**Stage 1 Quality Audit Report  
Social Housing Bundle 4, Development  
at the Stanley Street Depot, Dublin 7**

<b>Client:</b>	Dublin City Council
<b>Document No:</b>	SHB4-SSD-RP-ORS-CS-P3-0001

This report documents the findings of a Stage 1 Road Safety Audit (RSA) carried out with respect to the proposed Social Housing Bundle 4, Development at the Stanley Street Depot, Dublin 7.

#### Problem No.1: Visibility at Crossing Points

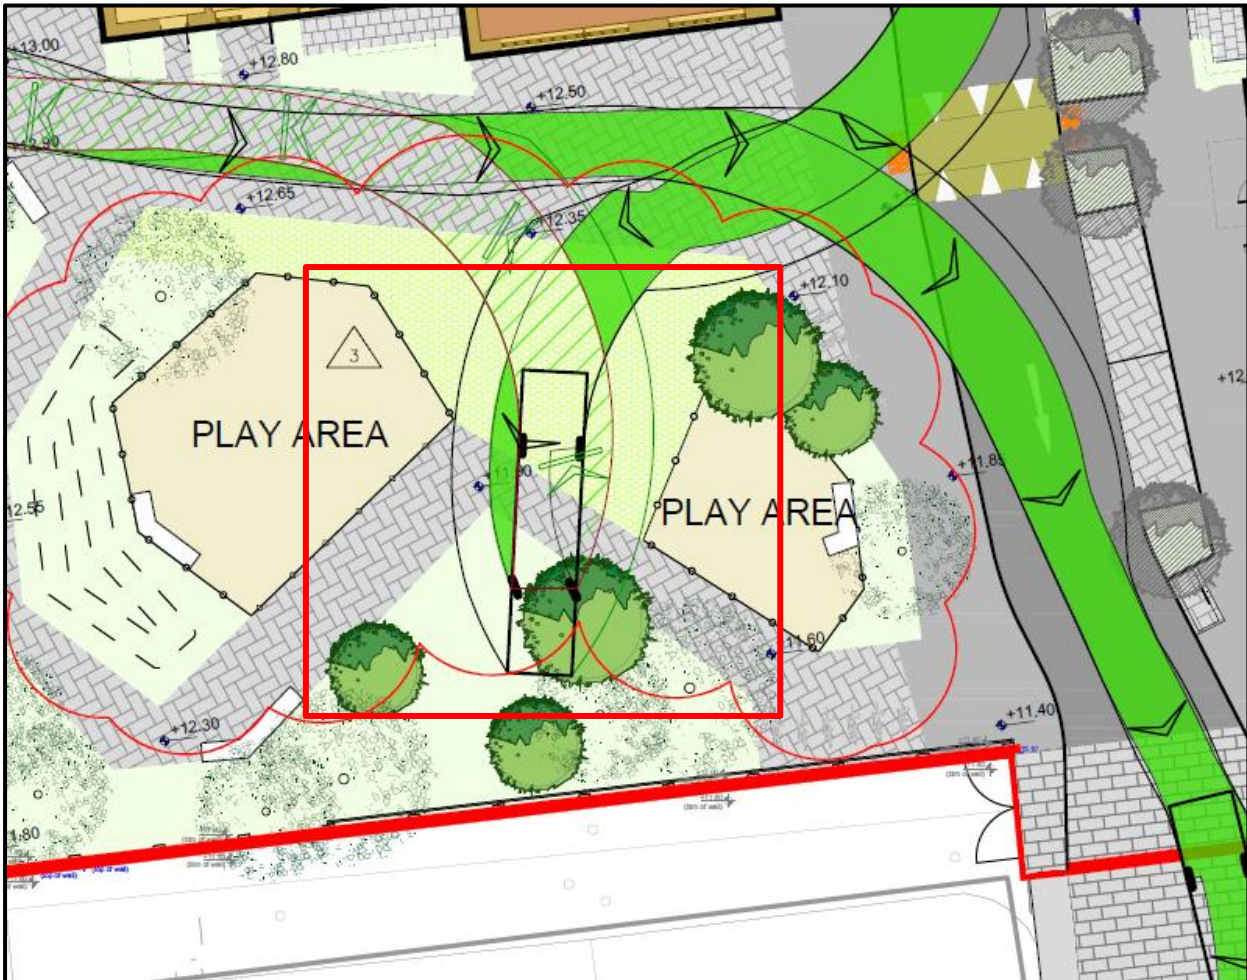
The audit team is concerned about visibility at the proposed crossing points within the scheme due to the proposed landscaping proposed next to the crossing points. The audit team is concerned that the proposed landscaping may impact the visibility of users utilising the crossing and may also restrict visibility of vulnerable users for motorists approaching the crossing points.

The design team should ensure that proposed landscaping does not restrict the visibility for vulnerable users at crossing points.

## Problem No.3: Visibility at Crossing Points

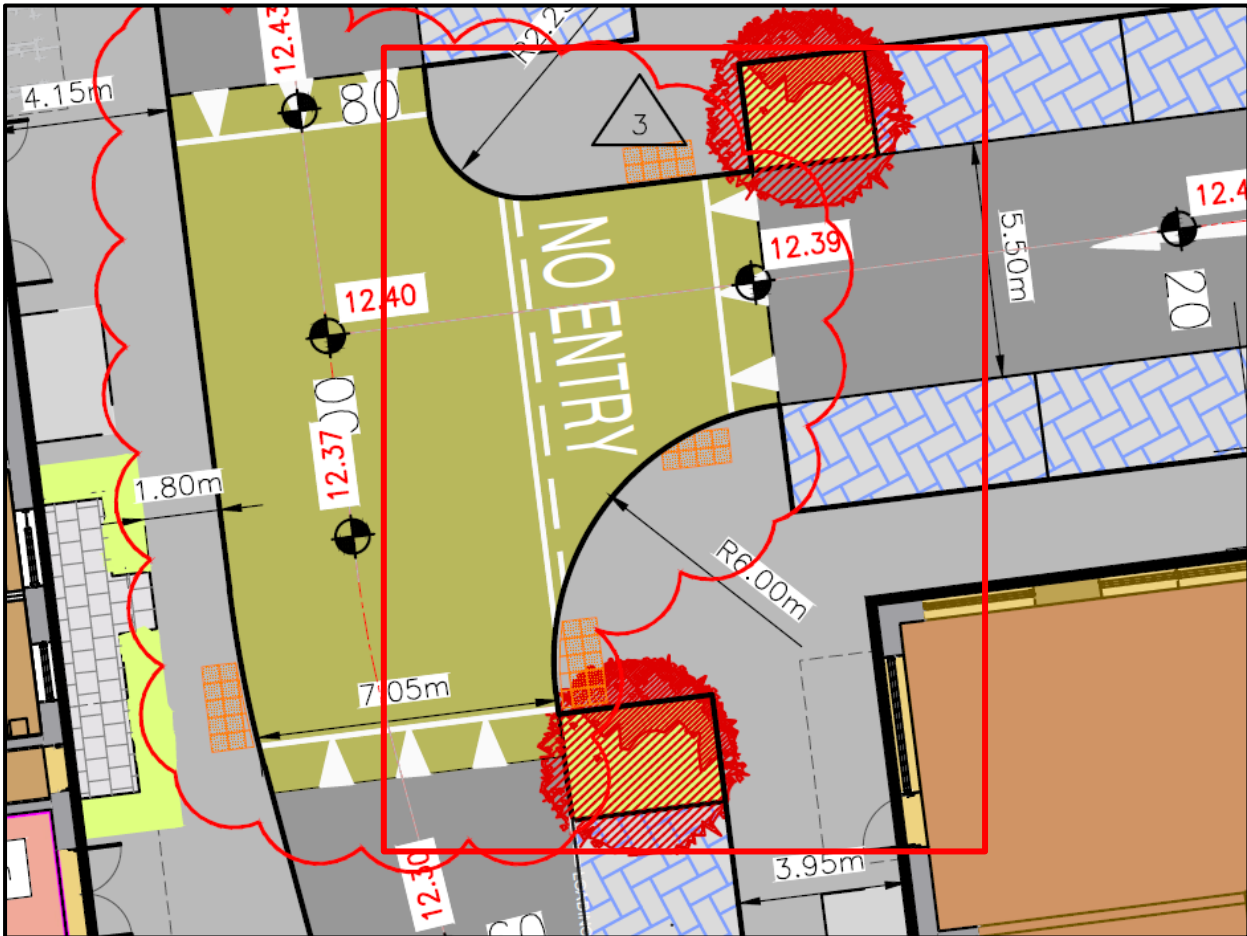
The audit team is concerned about visibility at the proposed crossing points within the scheme due to proposed carparking proposed in close proximity to the crossing points. The audit team is concerned that parked cars may impact the visibility of users utilising the crossing and may also restrict visibility of vulnerable users for motorists approaching the crossing points.

The design team should ensure that parked cars in the proposed parking spaces do not restrict the visibility for vulnerable users at crossing points.

## Problem No.4: Control at Internal Junction

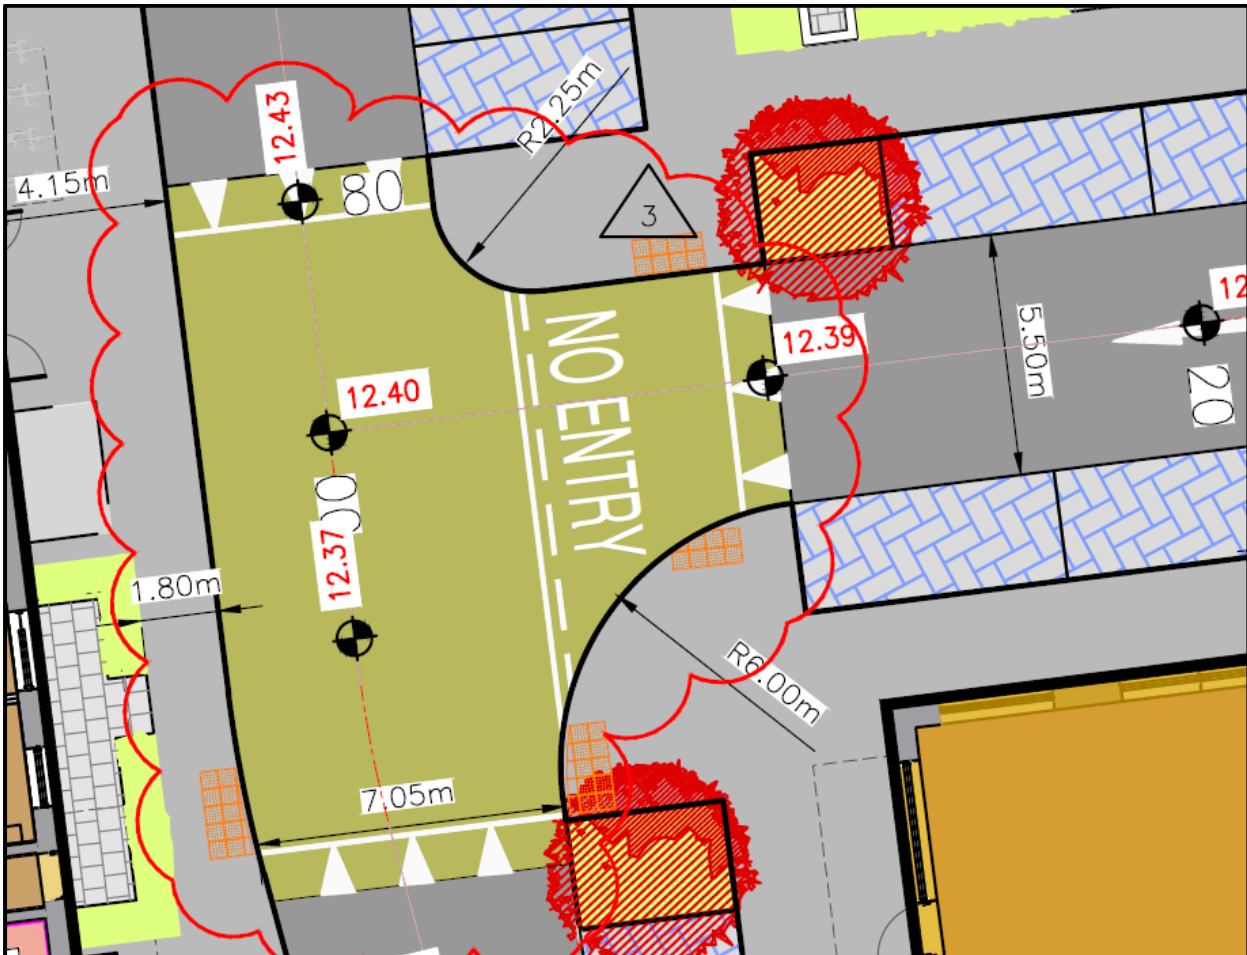
The audit team note that there is no proposed control for vehicles travelling west along the one-way street at the internal junction arrangement which could lead to vehicles failing to stop at the junction which could potentially result in conflicts on the two-way street.

The design team should ensure that a stop control arrangement is proposed at this junction for vehicles travelling west from Grangegorman Lower Road.

## Problem No.5: No Crossing Point on Desire Line

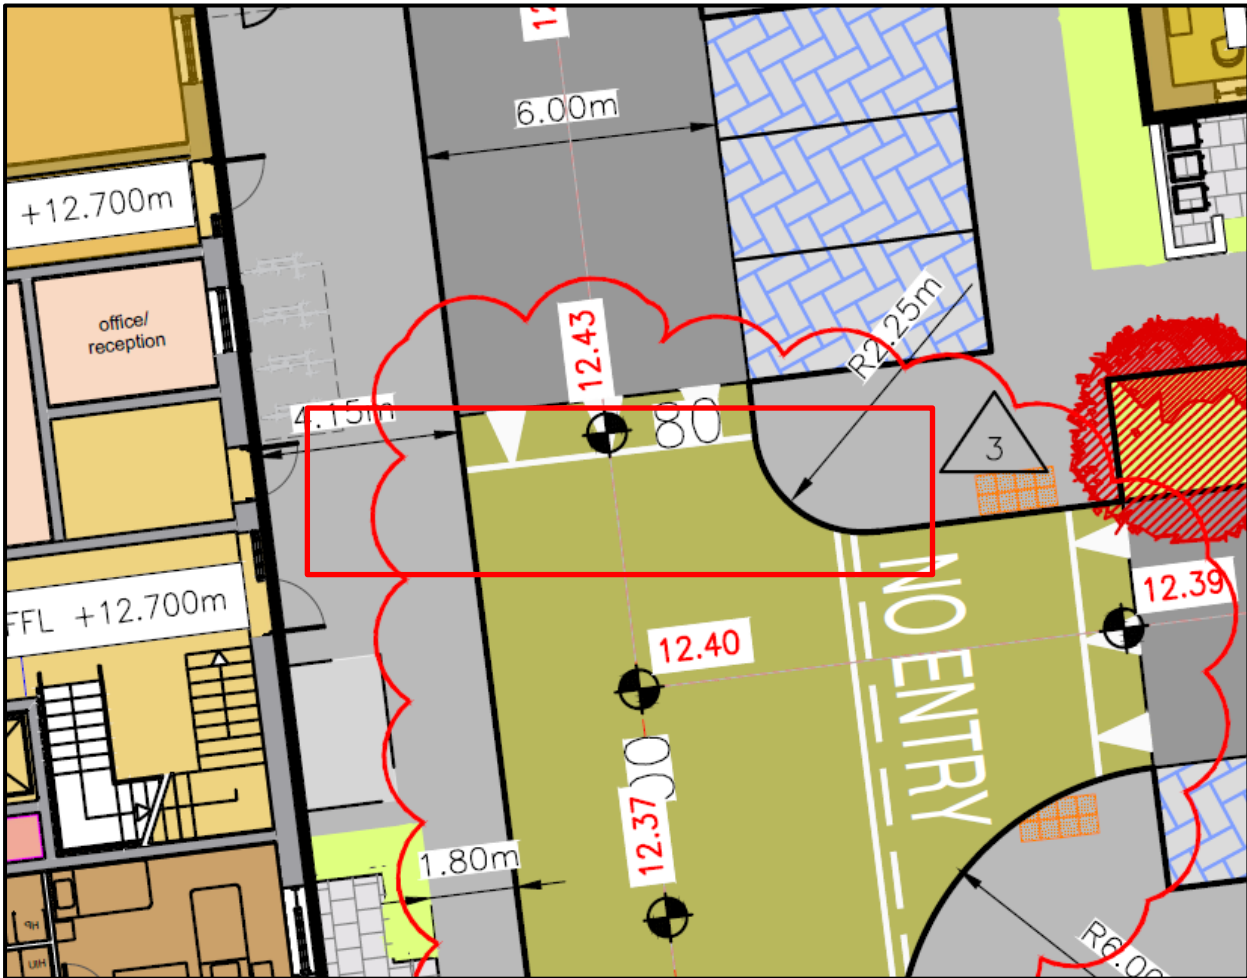
The audit team note from the provided drawings that there is not crossing point at the identified location to allow users in the northern units to cross the carriageway in the direction of Stable Lane. This could result in users crossing the carriageway in undesigned location which could result in potential vehicle collision with vulnerable users.

The design team should ensure that there is a dedicated crossing point at this location to allow users to safely crossing the carriageway.

## Problem No.6: Protection to Detention Basin Area

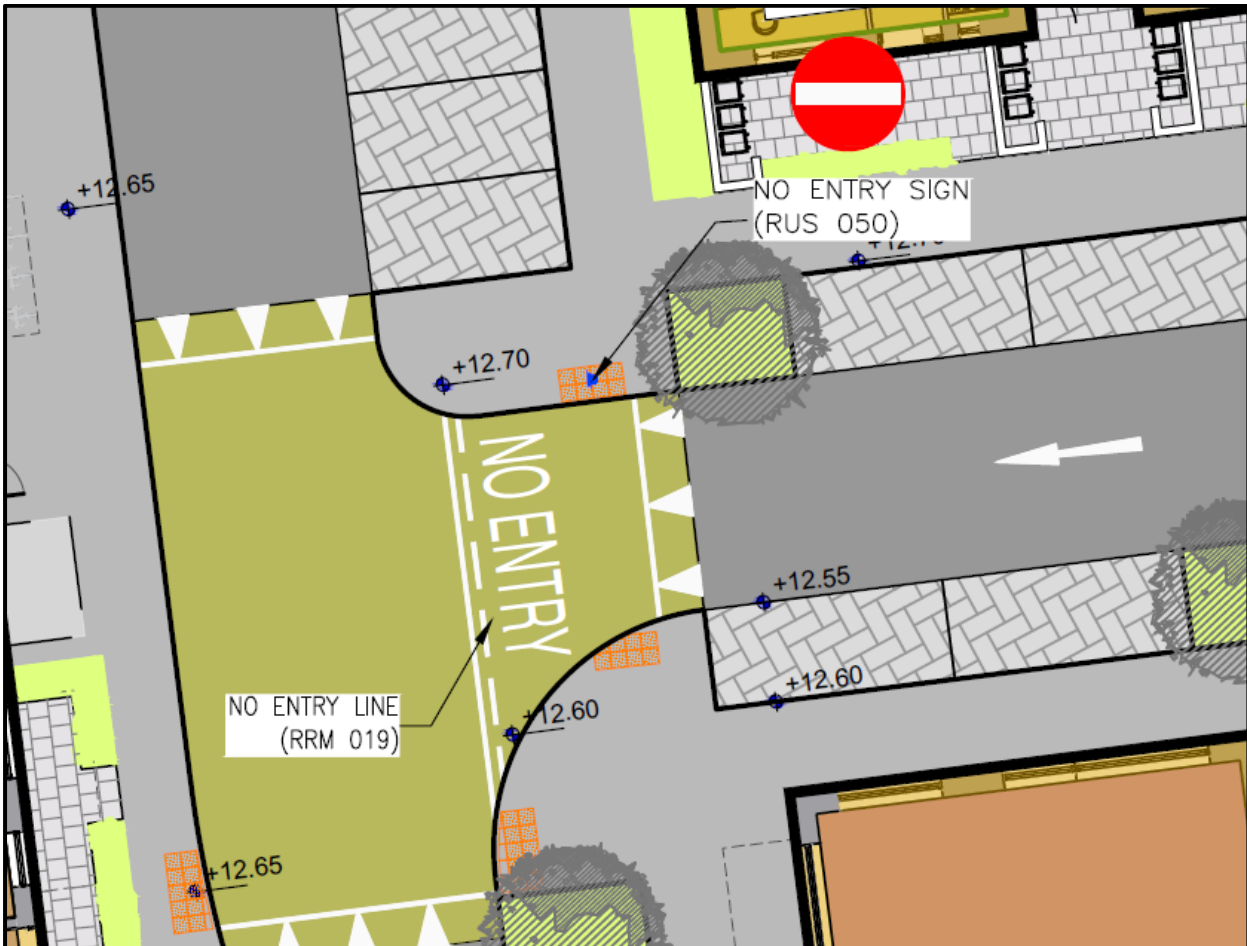
The audit team note that the detention basin runs parallel to pedestrianised surface which could be a high footfall area for children in particular. As no protection is provided for vulnerable users, the audit team has concerned that a vulnerable road user could inadvertently enter the bioretention area which could result in potential drowning incidents.

The design team should provide adequate protection to the detention basin and any protruding pipework is provided to prevent vulnerable users from entering the pond area.

## Problem No.7: 'No-Entry' Sign Positioned on Crossing Point

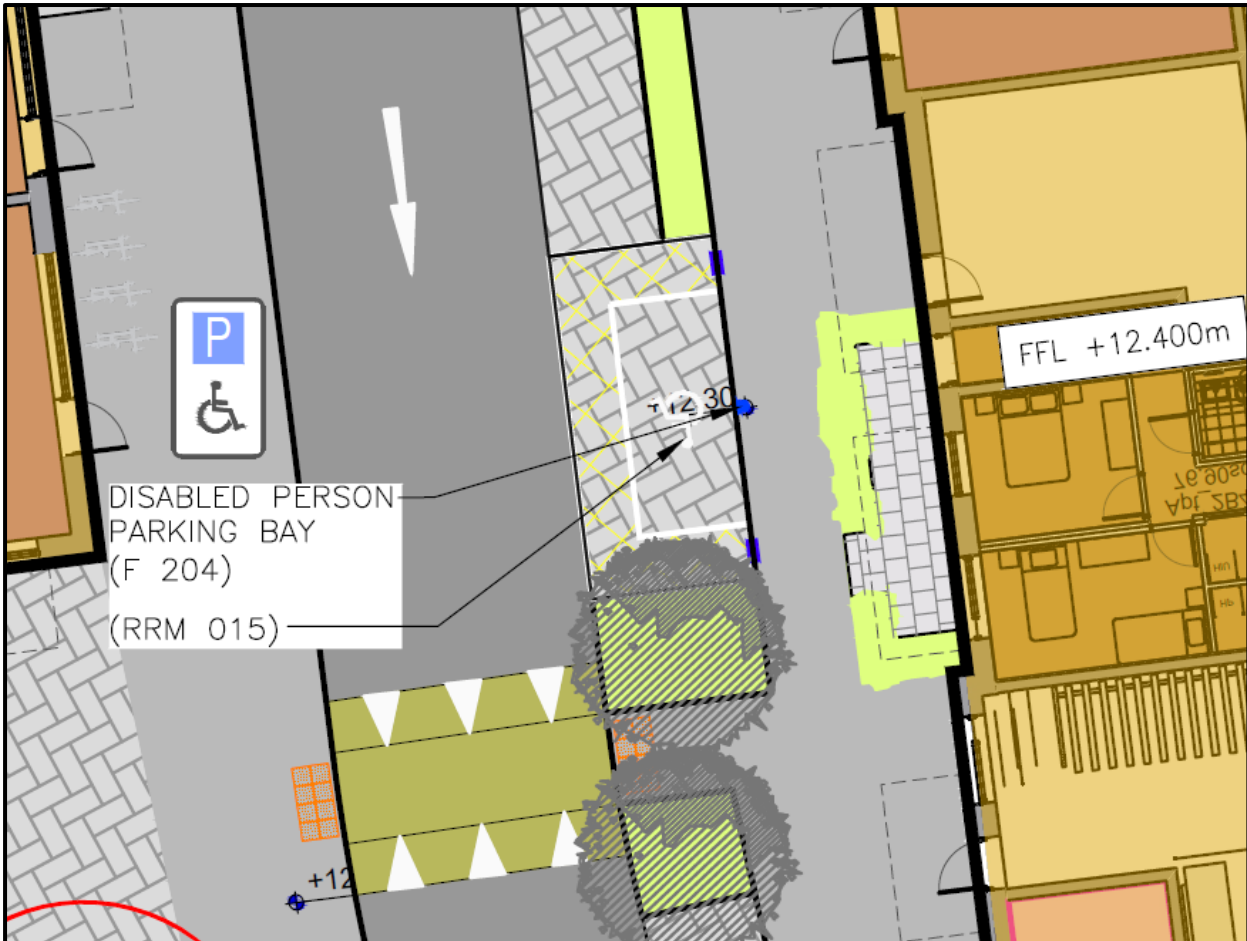
The audit team note that there are public lighting columns which appears to be positioned on the crossing point identified. The positioning of this column will restrict the movement of vulnerable users and will result in a safety hazard for visually impaired users.

The design team should ensure that this sign is relocated away from the crossing point to mitigate the safety risk.

## Problem No.9: Width of Junction

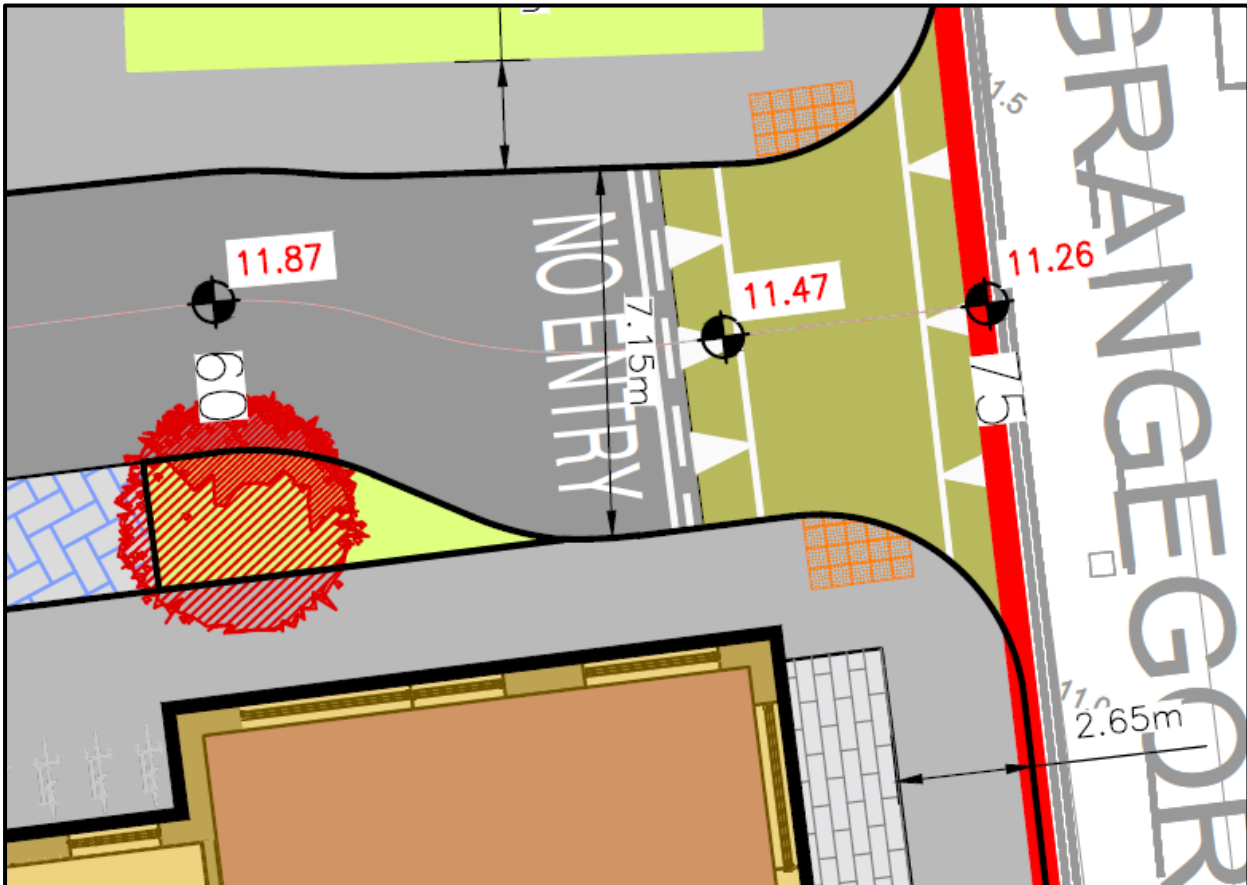
The audit team note that the proposed junction arrangement at Grangegorman Lower Road appears excessively wide for single vehicle entries and could encourage higher speeds of vehicles accessing the development. This creates a safety risk for vulnerable users at the crossing if vehicles enter the development at higher speeds.

The design team should ensure reduce the width of this access to mitigate the safety risk identified.
